Certificate of Appropriateness Application

BAR # 26-0016

110 3rd Street, NE; TMP 330222000

Project: Window replacements

DMWPV OFFICE FLOOR PLAN v.3

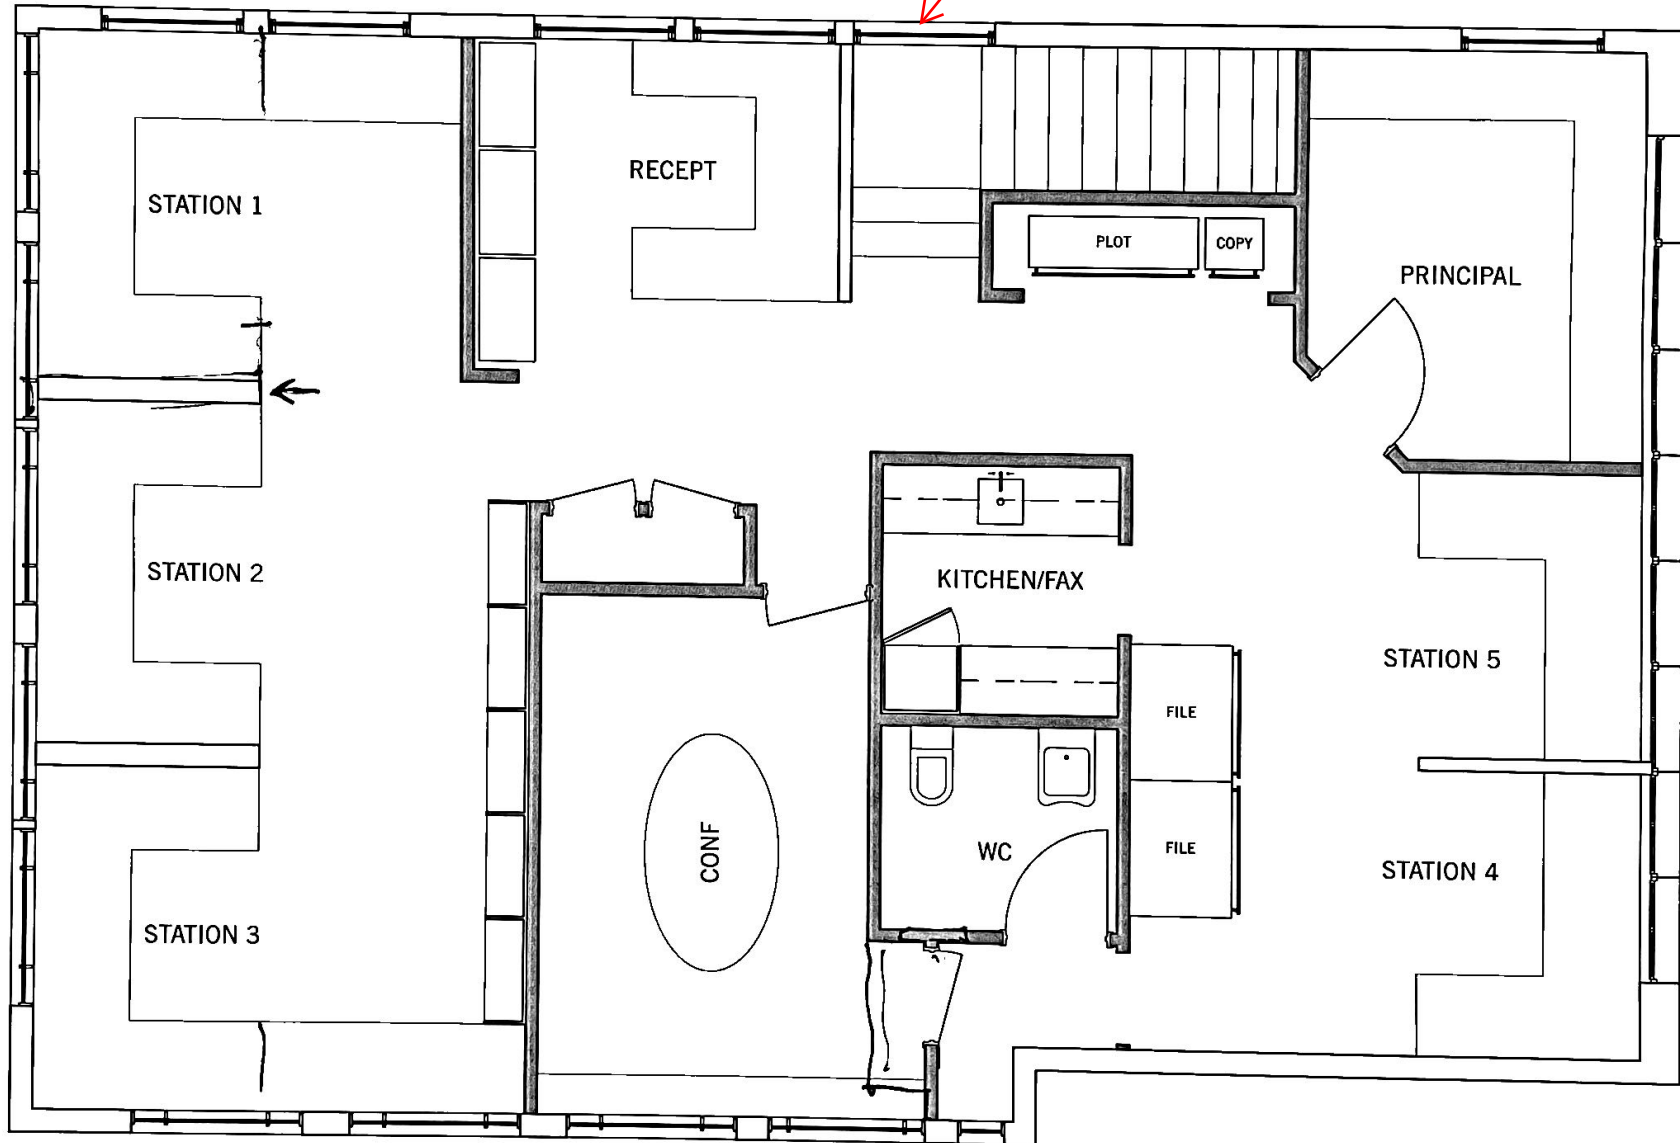
Photographs provided by the application show varying levels of age and deterioration, and staff cannot confirm whether the windows are irreparable. The applicant states they will match the light layout at each location and retain the existing steel frames. The selected window is the Pella Reserve series with square mullions.

BAR should discuss if replacement of the windows would be appropriate for this property and this ADC District. In reference to Ch. 4.C.8 of the Design Guidelines, “If a window on the primary façade of a building must be replaced and an existing window of the same style, material, and size is identified on a secondary elevation, place the historic window in the window opening on the primary façade.” In the past we’ve encouraged applicants to consider this recommendation as an alternative to replacing all the windows.

A rigid application of the guidelines would recommend repair in lieu of replacement, however the BAR has recently approved window replacements for 20th-century buildings.

Staff does not recommend replacement of the windows on the primary façade, and suggests the applicant consider repair and reglazing of the existing frames. However, replacements at the side and rear elevations of the second floor may be appropriate.

Having considered the standards set forth within the City Code, including the City's ADC District Design Guidelines, I move to find that the proposed window replacements at 110 3rd Street NE satisfy the BAR's criteria and are compatible with this property and other properties in the District, and that the BAR approves the application with the clarification that the movable casement windows on the front facade depicted in the rendering provided by the applicant at this meeting are what is approved [and the rendering included in the BAR record].
